**PLANNING APPROVAL &
SUBDIVISION STAFF REPORT****Date: May 17, 2007**

<u>DEVELOPMENT NAME</u>	Mt. Zion Baptist Church (Ben Cummings, Agent)
<u>SUBDIVISION NAME</u>	Mt. Zion Subdivision, Unit One & Two
<u>LOCATION</u>	1001, 1007, 1009, & 1012 Adams Street and 263 North Pine Street (Southwest corner of Adams Street and North Pine Street & North side of Adams Street, 120'± West of North Pine Street, extending West to Kennedy Street and North to Basil Street)
<u>CITY COUNCIL DISTRICT</u>	District 2
<u>PRESENT ZONING</u>	R-2, Two-Family Residential
<u>AREA OF PROPERTY</u>	2 lots / 1.8± Acres
<u>CONTEMPLATED USE</u>	Planning Approval to allow expansion of an existing church, and Subdivision approval to create two lots.
<u>TIME SCHEDULE FOR DEVELOPMENT</u>	Not provided.
<u>ENGINEERING COMMENTS</u>	Must comply with all storm water and flood control ordinances. Any work performed in the right of way will require a right of way permit.
<u>TRAFFIC ENGINEERING</u>	Driveway number, size, location, and design to be approved by Traffic Engineering and conform to AASHTO standards.

SITE PLAN

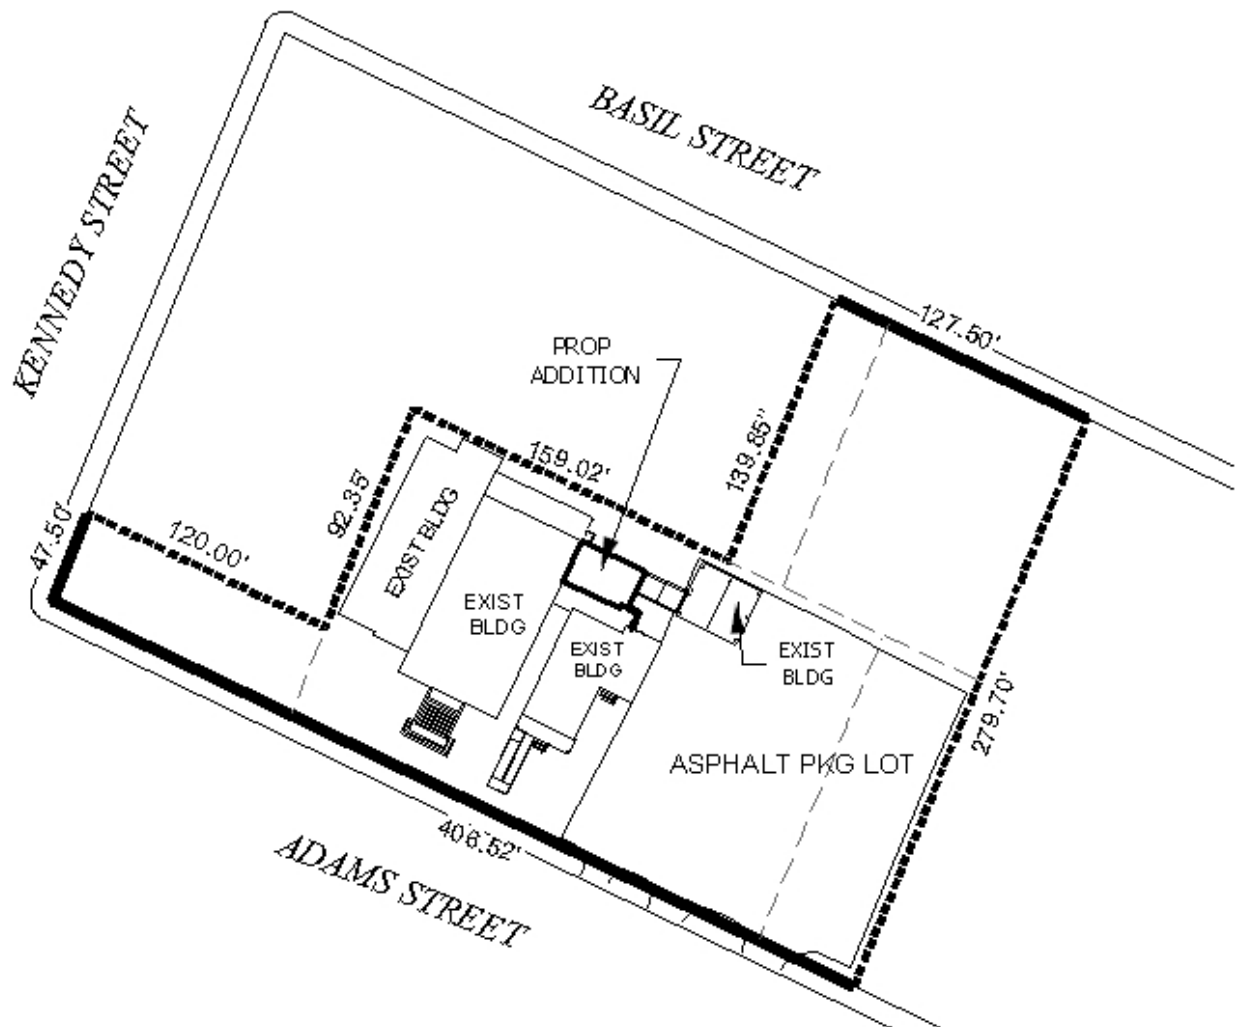
The 25-foot minimum building setback line from all street frontages is not shown on the preliminary plat or Planning Approval site plan but would be required on the final plat and site plan, if approved.

Section V.D.6. of the Subdivision Regulations states that “*where necessary by reason of curb radii, property lines at street intersection corners shall be arcs having radii of at least 10 feet, or shall be chords of such arcs.*” The Subdivision plat and Planning Approval site plan should be revised to reflect this requirement of the Subdivision Regulations.

Finally, the labeled scale on the site plan does not reflect the actual scale of the drawing. Subsequently, several dimensions are incorrect. The scale labels should be corrected and the dimension corrected as needed.

- 1) completion of the Subdivision process;
- 2) placement of a note on the site plan stating that the site is limited to the three (3) existing curb-cuts onto Adams Street;
- 3) revision of the site plan to show compliance with Section V.D.6. of the Subdivision Regulations;

- 4) depiction of the required 25-foot minimum building setback line from all street frontages
- 5) depiction and provision of a 6-foot high (minimum) wooden privacy fence or vegetative buffer that complies with Section 64-4.D.1. of the Zoning Ordinance along the 159-foot \pm wide property line behind the existing and proposed church structures;
- 6) placement of a note on the site plan stating that a new application for Planning Approval will be required for any future changes to the site plan, including the use of the grassy areas or adjacent lots for parking;
- 7) revision of the site plan to show the correct scale of 1 inch equals 20 feet, and correction of the dimensions as necessary; and
- 8) provision of a revised Planning Approval site plan to the Planning Section of Urban Development prior to the signing of the final plat
